Access Compliance Report

Public Rights-of-Way

Intersection ID: 5236	Main Street: COPPALA_DR	Cross Street: KORNIV_DR	Location: NE
ADA ID: 4146F8048804	Ramp Type: PerpDiag	Initial Pass/Fail: Pass	Overall Compliance: No
Severity Score: 10.25			
Codes/Mitigation Info/Possible Solution		Field Measurements/Component Compliance

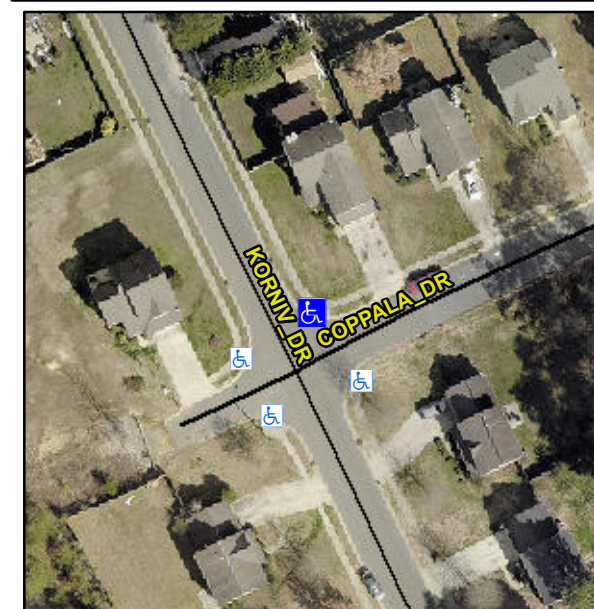
Compliance	Description	Data	Compliance	Description	Data
N/A	Ramp Length (in)	55.0	Yes	Ramp Slope (%)	7.3
Yes	Ramp Width (in)	57.0	No	Ramp XSlope (%)	3.2
N/A	Flare Type LT	Sloped	N/A	Flare Type RT	N/A
N/A	Flare Slope LT (%)	1.7	Yes	Flare Slope RT (%)	8.3
N/A	Flare Traversable LT?	Yes	N/A	Flare Traversable RT?	Yes
No	Landing Length (in)	47.0	No	DWS Provided?	No
Yes	Landing Width (in)	57.0	N/A	DWS Contrast?	No
Yes	Landing Slope (%)	1.3	N/A	DWS Length (in)	N/A
No	Landing X Slope (%)	3.9	N/A	DWS Full Width?	No
N/A	Landing Curb? (Y/N)	No	N/A	DWS Offset (in)	N/A
N/A	Shared Landing?	No			
Yes	Gutter Ponding?	No	Yes	Gutter Slope (%)	1.8
Yes	Gutter Lip Ht (in)	0.0	No	Gutter X Slope (%)	6.0
N/A	Painted X Walk1?	No	N/A	Painted X Walk2?	No
	X Walk 1 Direction	To W		X Walk 2 Direction	To S
N/A	X Walk 1 Width (in)	N/A	N/A	X Walk 2 Width (in)	N/A
	X Walk 1 Slope (%)	4.4		X Walk 2 Slope (%)	7.2
	X Walk 1 X Slope (%)	5.6		X Walk 2 X Slope (%)	0.9

N/A	Ramp inside XWalk1?	N/A	N/A	Ramp inside XWalk2?	N/A
	Road Slope (%)	1.5	N/A	Clear Space?	Yes
	Road X Slope (%)	7.3	N/A	Clear Space to XWalk (in)	N/A
Yes	Any Obstructions?	No	Yes	Storm Grate/Utility Hazard?	No
	Obstruction Type			Storm Grate/Utility Type	
		N/A			N/A
		Yes		Surface Condition? (G/P)	Good

Remove & Replace Curb Ramp With Two New Directional Ramps or Equivalent. Remove & Replace Gutter.

R304.5.3, R304.2.1, R305
